SERVICE BULLETIN

Service Bulletin No.: DA20-73-05 Rev 0

Title: Introduction of a new Fuel Pump Assembly

Figure 1 – Drain Tube Assembly

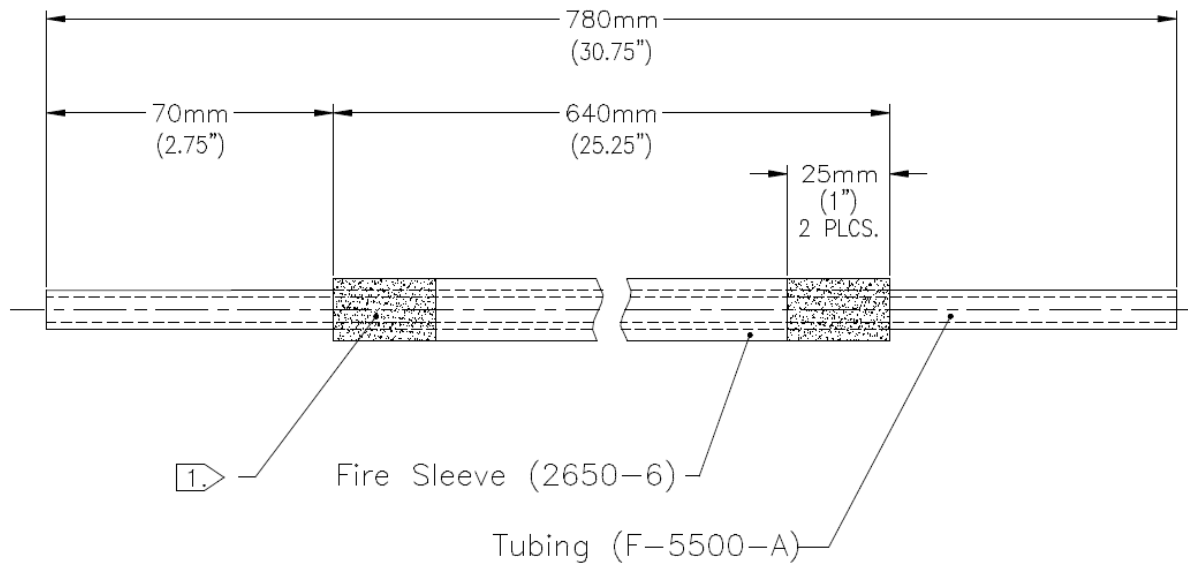
- 10.2.1 Assemble Drain Tube as shown in Figure 1.
- 10.2.2 Install one end of the Drain Tube Assembly onto the drain fitting on the mechanical fuel pump. Route the Drain Tube Assembly inboard of the cooling air intake and outboard of the right side exhaust risers and coolant pipes. Secure the Drain Tube Assembly to the engine mount using loop clamps as shown in Figure 2.
CAUTION:
The drain tube should be installed without kinks or tight bends. It must provide a continuous base slope toward the Vent Tube.

- 1. DIP TWICE EACH END OF STRATOFLEX FIRE SLEEVE INTO CONTAINER WITH STRATOFLEX FIRE SLEEVE END DIP P/N 5027 BEFORE ASSEMBLY. ALLOW SEALANT TO DRY BETWEEN APPLICATIONS.

Figure 2 – Drain Tube Installation

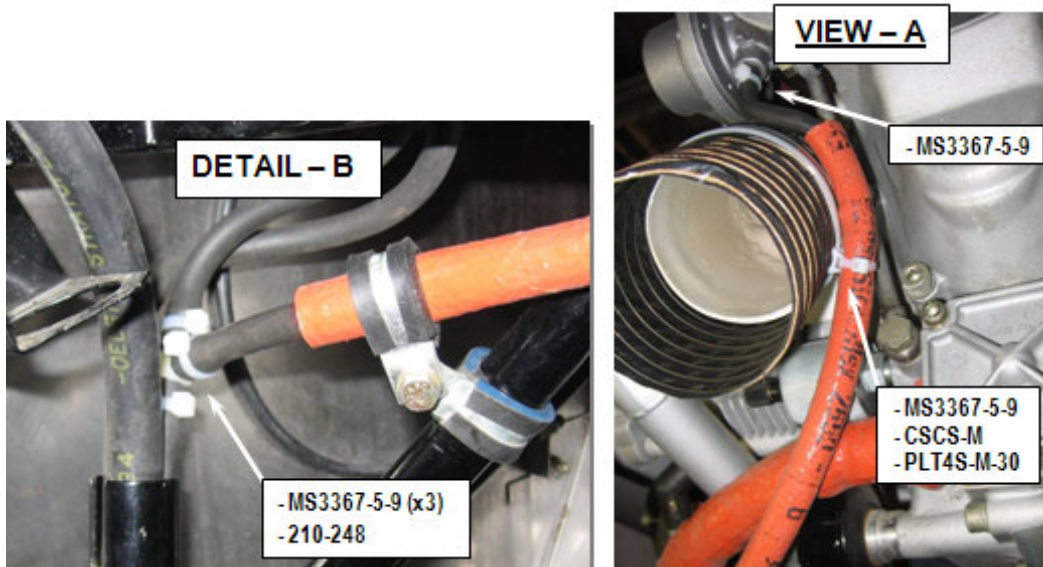
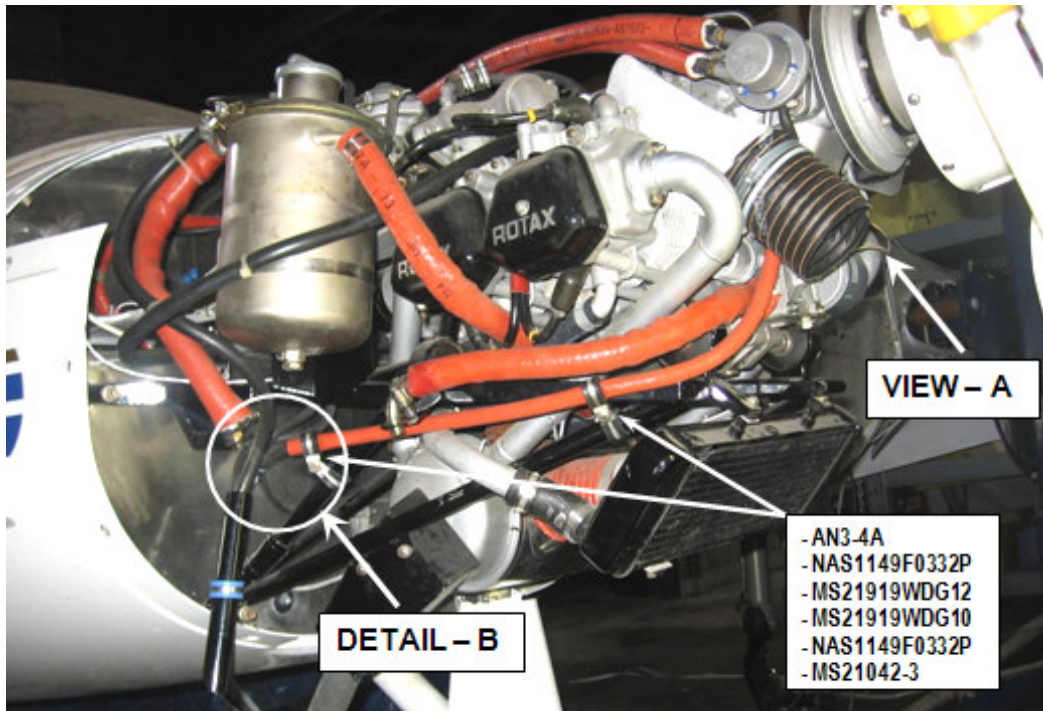
- 10.2.5 Secure all drain tube connections with self locking cable ties (Figure 2).
- 10.2.6 Secure Fuel Pump Drain Tube to cooling air intake with two cable ties and 90° Spacer as shown in Figure 2.

Figure 3 – Drain Tube Installation (Schematic)

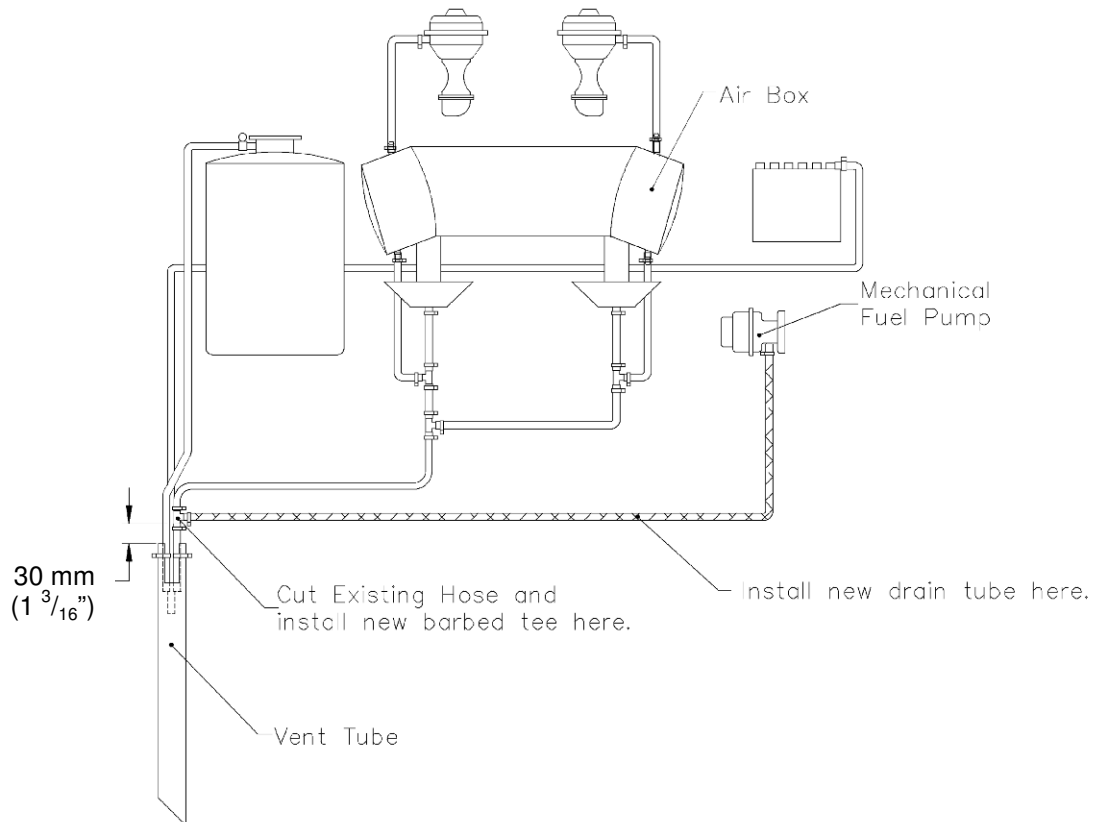
- 10.2.3 Cut existing fuel drain hose 30 mm ($1 \frac{3}{16}$) above Vent Tube and install supplied barbed tee fitting as shown on Figure 3.
- 10.2.4 Connect Fuel Pump Drain Tube to barbed tee.
